## Walkable Midtown: The Midtown-St. Albans Area Plan

Planning Commission  
Committee of the Whole  
Oct. 22, 2020

# Status Update

# St. Albans-Bush Area FLUM (CP-2C-20)

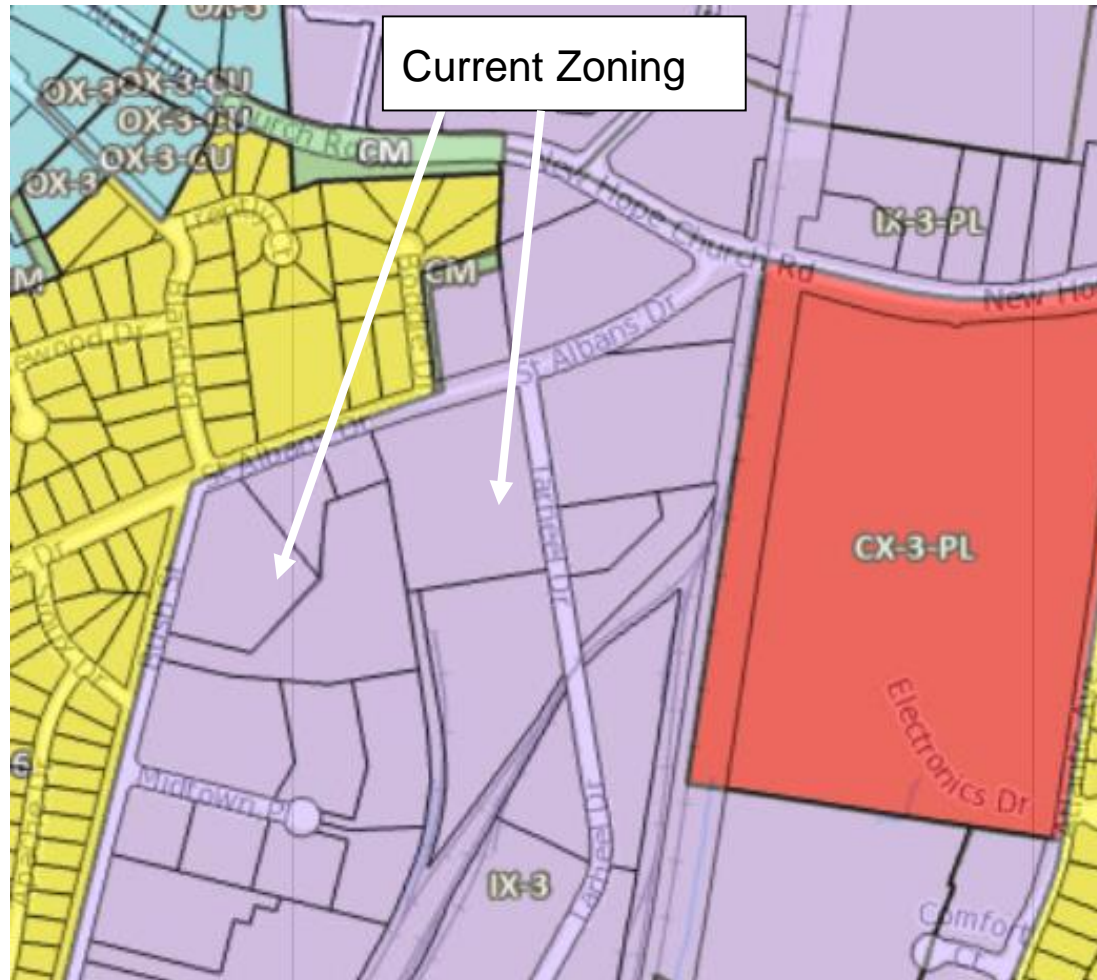
**Comment:** FLUM for St. Albans/Bush area should support office/other commercial uses

1. Revise recommendation to retain existing Business and Commercial Services designation while including language that also regards housing, including ground-floor housing, as a reasonable future land use. This option would still align with plan principles while addressing concerns from property owners.

2. Retain Plan recommendation of Medium Density Residential. This option reflects the plan recommendation but does not address concerns from property owners.

3. Revise recommendation to a category that better facilitates housing while also supporting office and retail uses. Examples include Office and Residential Mixed Use or Neighborhood Mixed Use. This option still aligns with plan principles and partially addresses concerns from property owners.

4. Revise recommendation to retain existing Business and Commercial Services designation. This option would address concerns from property owners but would not align with plan principles.

# St. Albans-Bush Area Height (CP-2A-20)

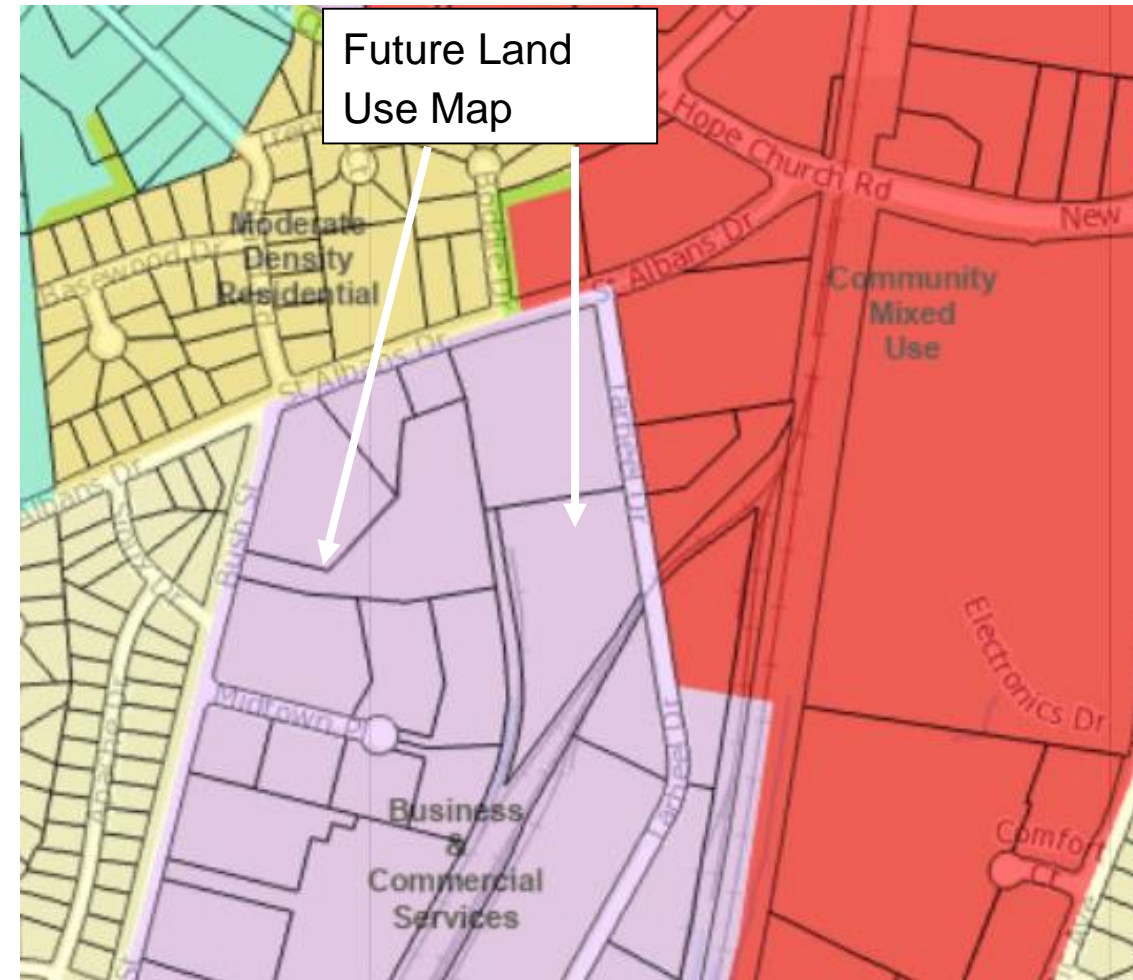
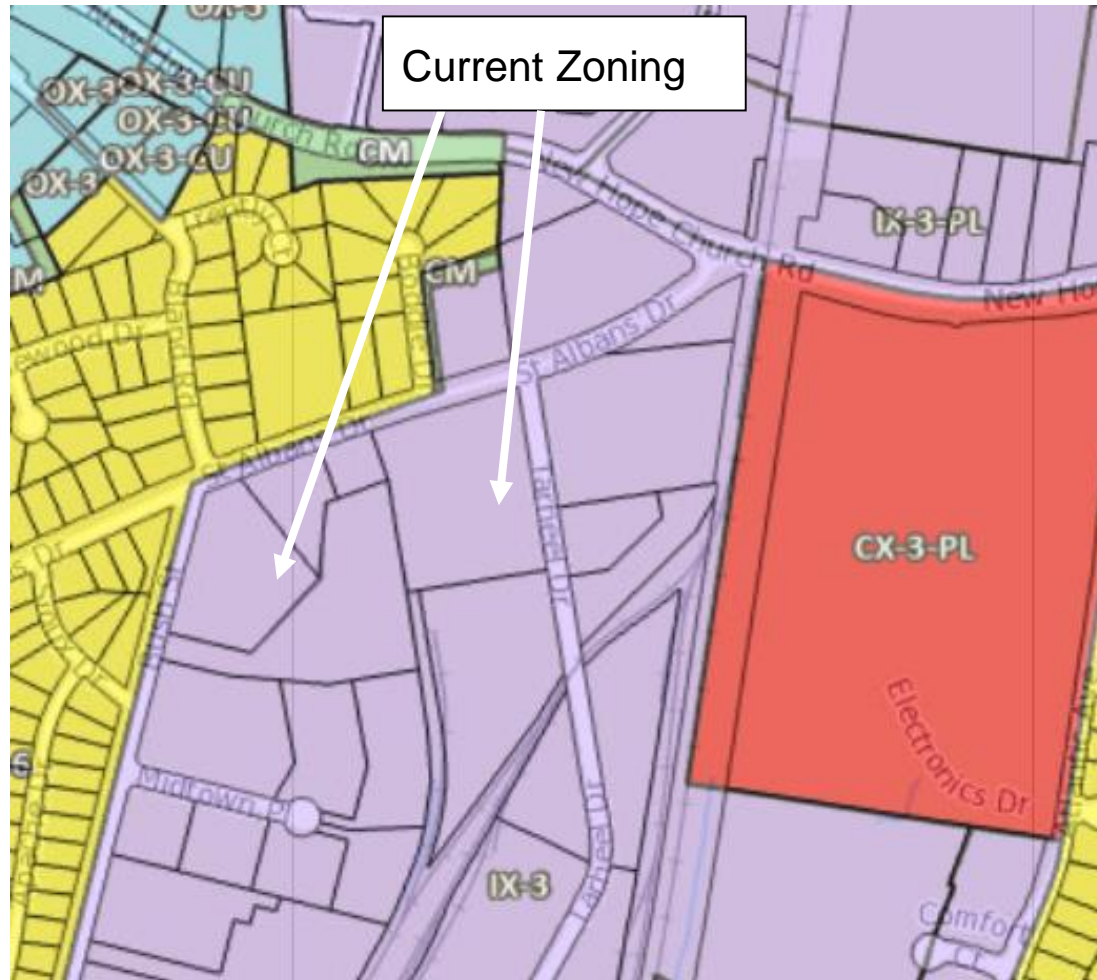
**Comment:** More height (12 stories) should be allowed in the St. Albans/Bush area. Plan recommends 4/5.

1. Retain Plan recommendation of five/four stories. This reflects the plan principle of allowing additional height while not creating a stark height transition to adjacent areas.
2. Revise recommendation to retain existing height guidance of three stories. This reflects the existing status quo in terms of zoning and height guidance.
3. Recommend additional height beyond four/five stories. Additional height beyond that explored by the plan process or current height guidance ideally should involve a new process. Any property owner or resident may request a FLUM change.

# Six Forks: Height (CP-2A-20)

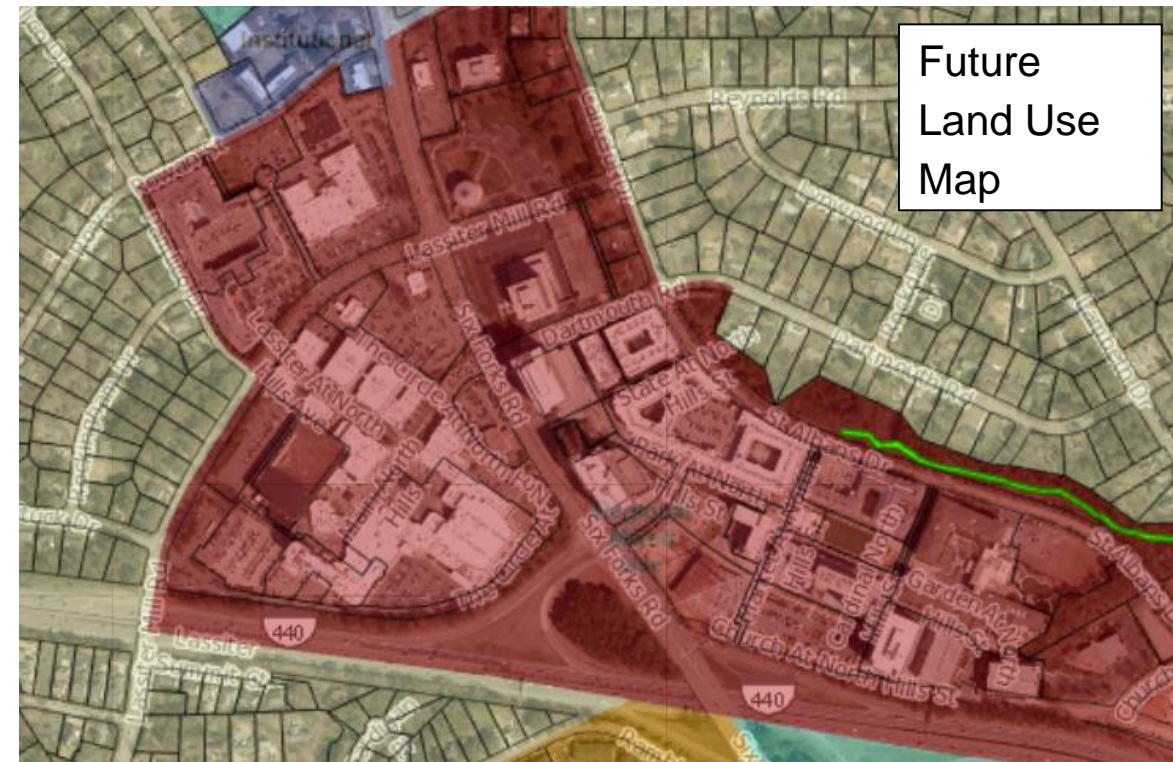
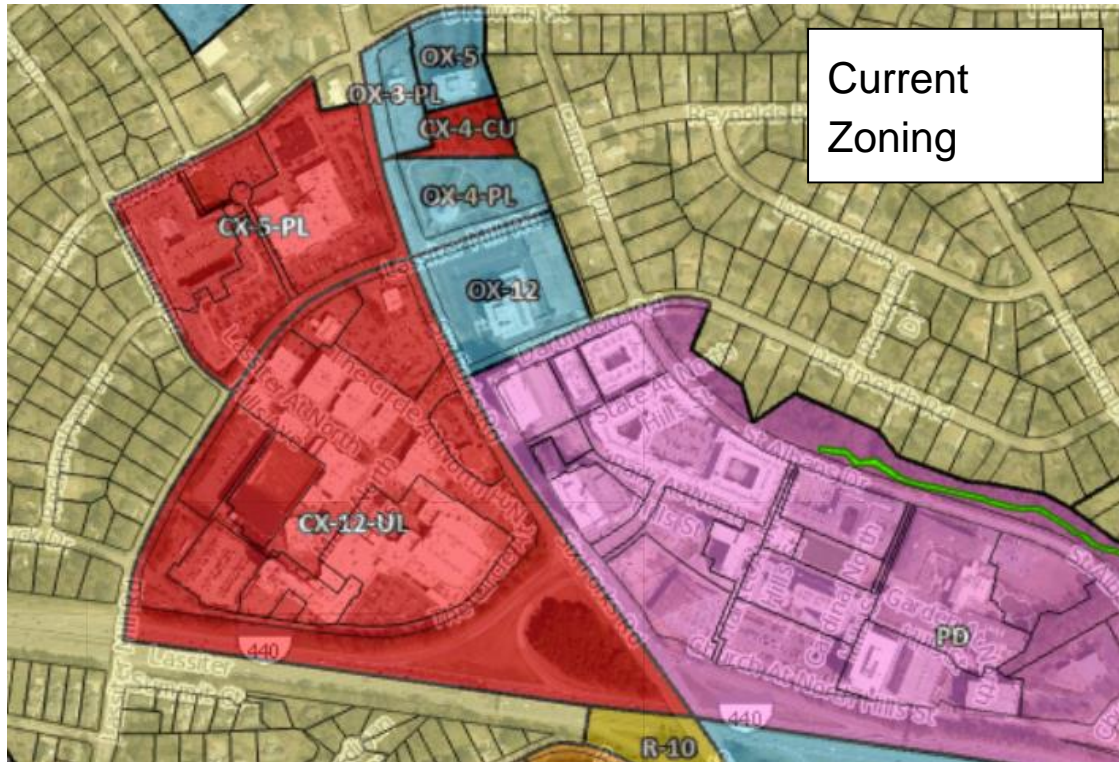
**Comment:** 20 stories is too tall along Six Forks Road

1. Retain Plan recommendation for 20-story guidance with transition down to four stories. This supports the plan principle of allowing more housing and employment options in a core portion of the study area that is walkable and served by transit.
2. Revise recommendation to reduce height guidance to 12 stories. This reflects the existing zoning.

# Six Forks Frontage/Urban Form (CP-2A-20)

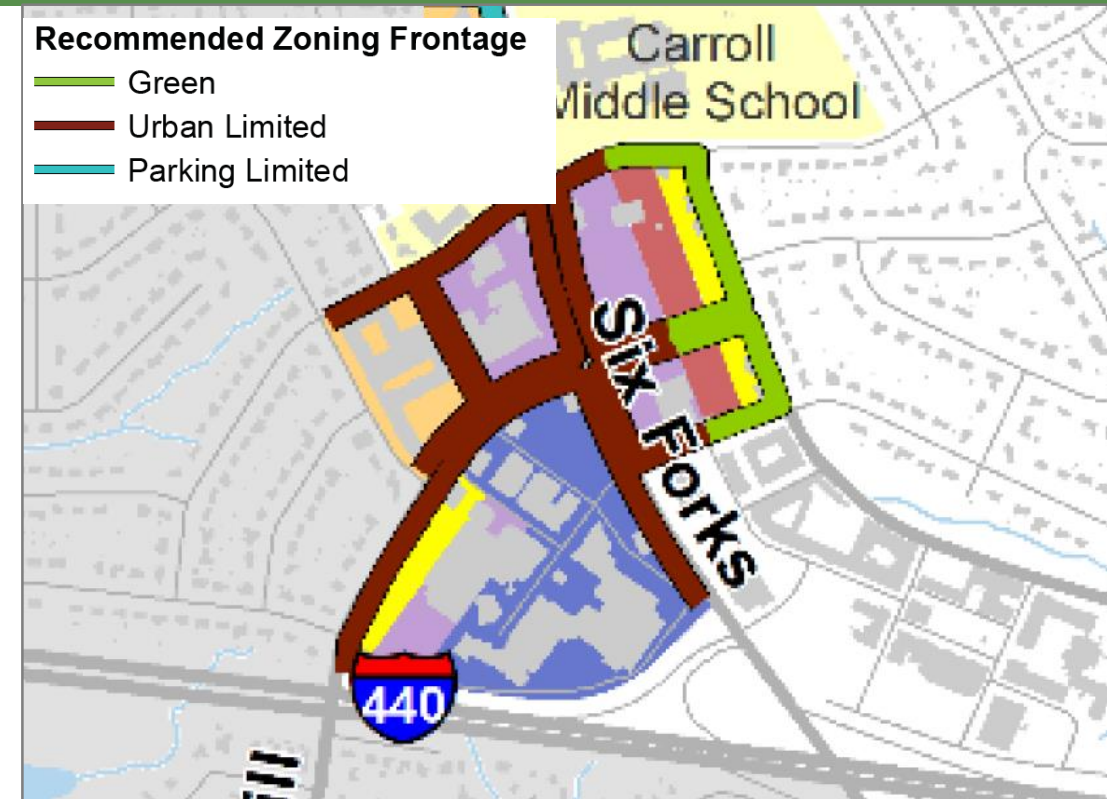
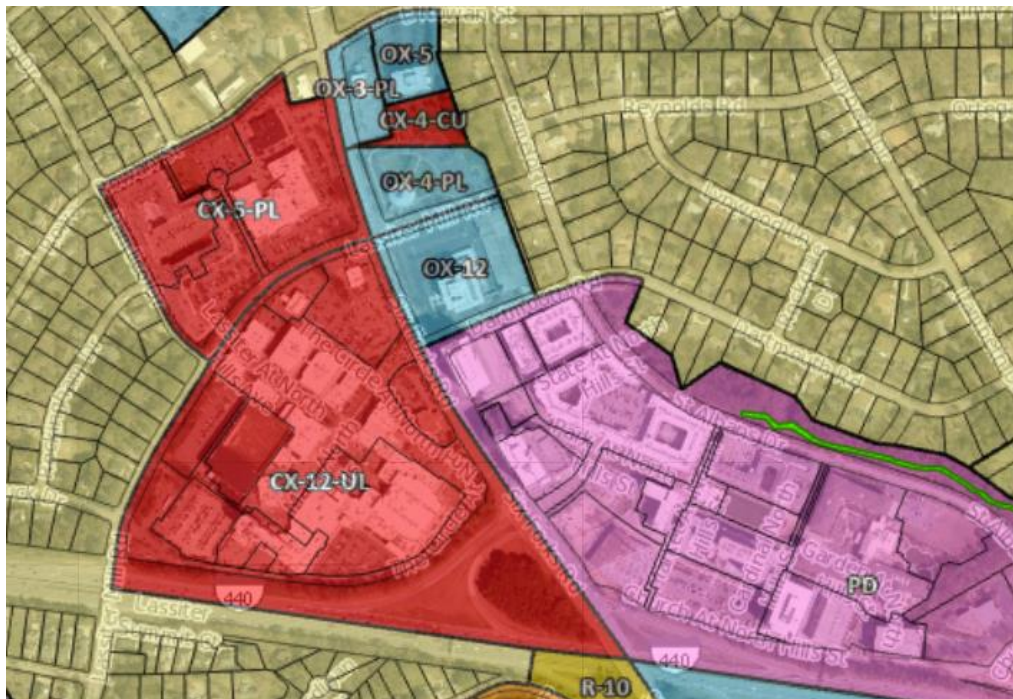
**Comment:** Six Forks should not have an urban frontage

1. Retain Plan recommendation for urban frontage. This reflects the plan principle of encouraging walkability.
2. Revise recommendation to specify a frontage with larger setbacks, allows parking between building and street, narrower sidewalks, and does not require any street-facing entrances. This does not align with plan principles supporting high levels of walkability.

# Six Forks/Wake Forest Height (CP-2A-20)

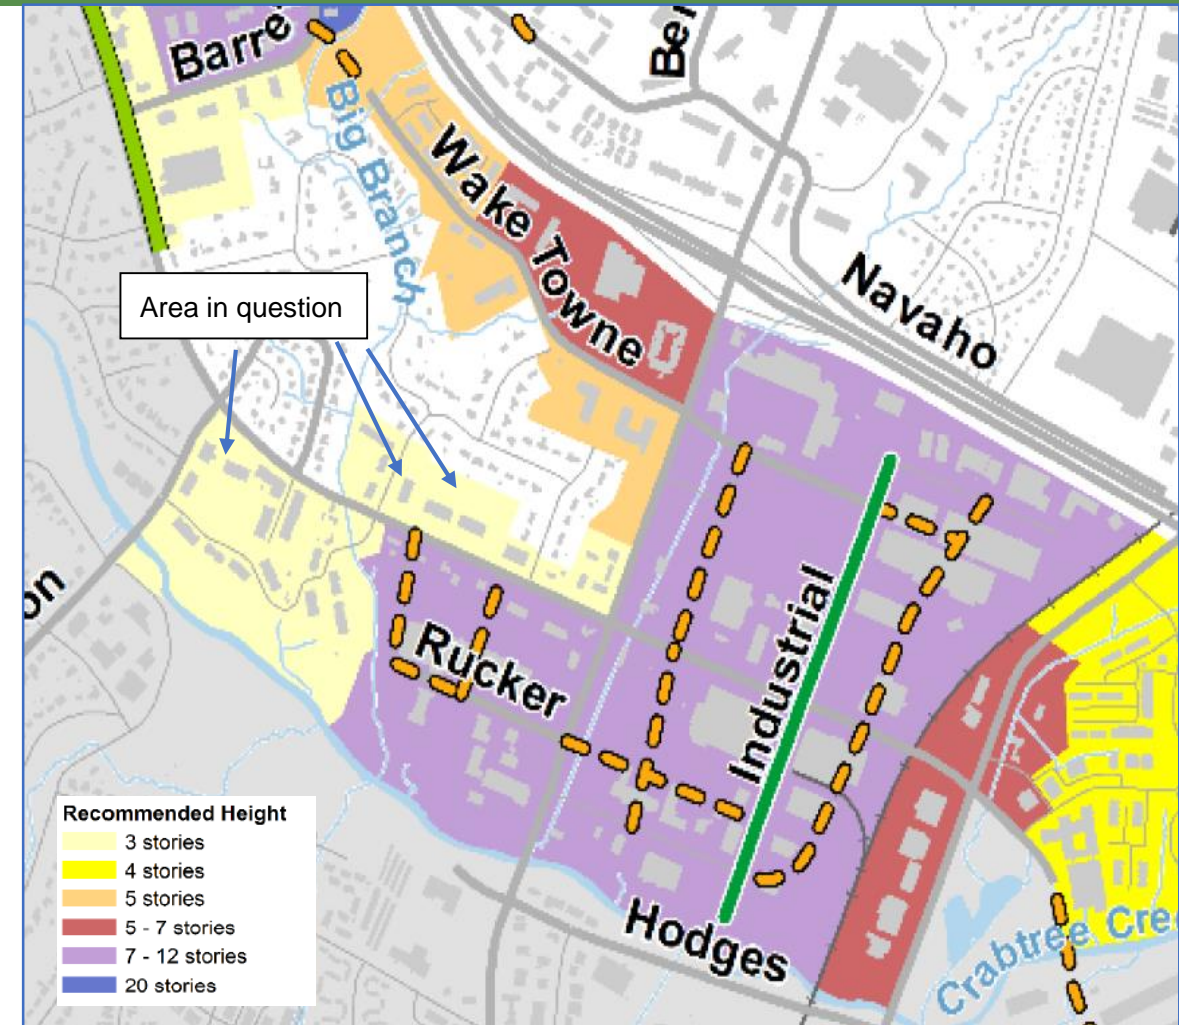
**Comment:** At least four stories should be allowed on Hobbs/nearby properties on Six Forks. Plan recommends three. Current zoning is three stories; current height guidance is 4/5 on north, 4 on south

1. Revise recommendation to allow existing Future Land Use Map guidance of four/five stories to remain. This addresses the comment and conforms to the status quo of height guidance in the area.
2. Retain plan recommendation for three-story height. This reflects the plan's recommendation for height transition but does not address the comment.
3. Revise plan recommendation to allow up to seven stories. Additional height beyond that explored by the plan process or current height guidance ideally should involve a new process. Any property owner or resident may request a FLUM change.

# Waterfront District: Height at Atlantic (CP-2A-20)

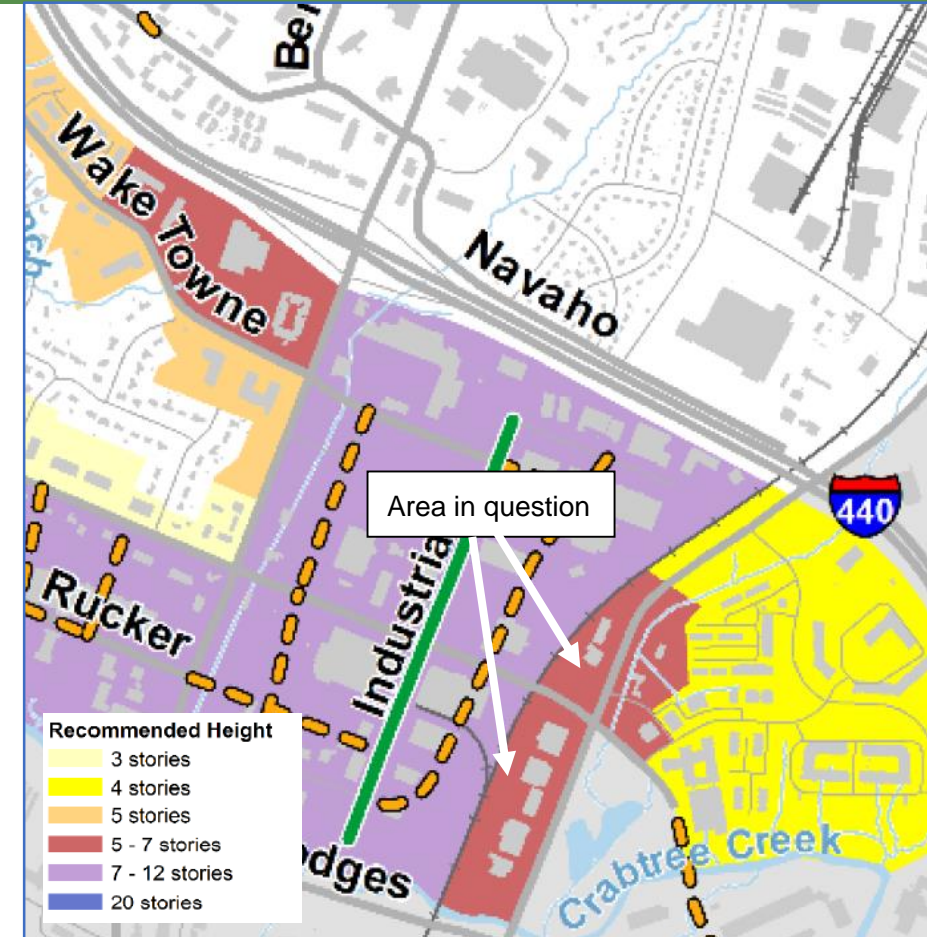
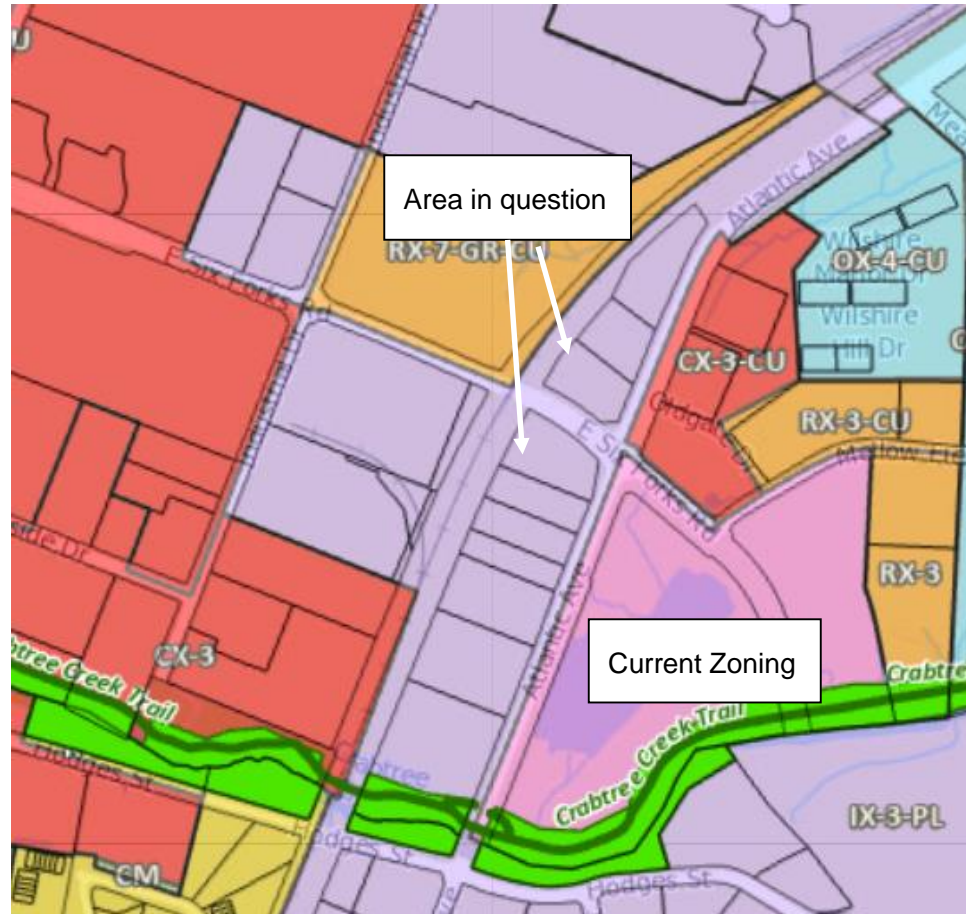
**Comment:** At least four stories should be allowed on Hobbs/nearby properties on Atlantic. Plan recommends 5-7. Current zoning is three stories; current general height guidance is five stories.

1. Revise recommendation to permit up to 12 stories along Six Forks Road and Atlantic Avenue south of Six Forks, reflecting planned frequent transit. This in effect slightly shifts the height transition area to the east. This addresses the comment and conforms to the status quo of height guidance in the area.
2. Retain plan recommendation of up to seven stories. This reflects the plan's recommendation for height transition but does not address the comment.
